ASSESSMENT REPORT			
Unique Document ID and Revision No:	ONR-OFD-AR-19-055 Revision 0	TRIM Ref:	2019/273315
Project:	Hartlepool Reactor 2 2019 Periodic Shutdown		
Site:	Hartlepool		
Title:	Hartlepool Reactor 2 2019 Periodic Shutdown: Structural Integrity Assessment of the Graphite Core Inspection Findings		
Nuclear Site Licence No:	59		
Licence Condition(s):	30, 28		
ONR Assessment Rating (Mandatory): <i>(Rating should be based on licensee's original safety case submission)</i>	GREEN		
COIN Service Order:	SVC4285368

**Hartlepool Reactor 2 2019 Periodic Shutdown – Assessment of the results of the  
Graphite Core Inspections**

Assessment Report ONR-OFD-AR-19-055  
Revision 0  
27 SEPTEMBER 2019

**Figure 2:** Circumferential defect observed in CR channel Q22 (References 1 and 14).

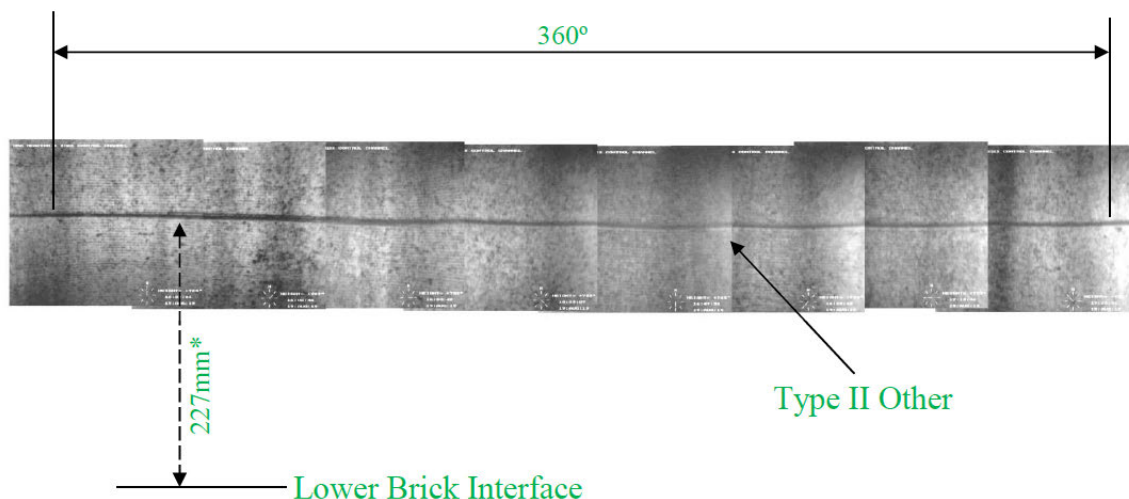
34. During the periodic shutdown, one CR channel (Q22) was visually inspected. During the inspection of Q22 a fully circumferential defect was observed in layer 10 approximately 227mm from the brick interface. Figure 1 shows a montage of the fully circumferential defect observed in Q22.

35. It was my opinion that the quality of the images did not allow for a conclusive opinion to be drawn on to the origin of the defect. It was therefore decided to conduct an additional intervention at the Wood offices in Knutsford. The findings from this intervention are reported in Reference 10.

38. From the video footage I observed, the defect appears to be consistent with other machining marks of limited depth. No crack-like feature appears to be present from the footage. A similar video footage showed that a similar defect taken had been observed in other CR channels, i.e. Layer 15 of 1L14 observed for HRA R1 in 2018 (Reference 11). This defect was classed as a manufacturing defect and had a similar morphology as the defect observed at the current outage. The video footage taken during commissioning indicates that the defect was likely to have been present at the time of construction (Reference 12). Hence, I am content that the defect observed in control rod channel Q22 is likely to have been caused by machining during the manufacture of the brick.

39. It is my opinion that a 360° scan of the defect (as performed for other similar observations) would have improved the sentencing of this defect. However, I consider that the video provides images of sufficient quality for the defect on Q22 to have been adequately sentenced by the GAP.

41. In my opinion, the irradiation in CR channels is likely to be too low for any significant driving force to be present at the location of the defect for the machining mark to develop into a crack. There is also no evidence from the inspection videos of any horizontal displacement which could indicate a crack. I therefore conclude that the circumferential defect observed in CR channel Q22 is unlikely to present a challenge to the structural integrity of the core or to result in impediment to CR entry.
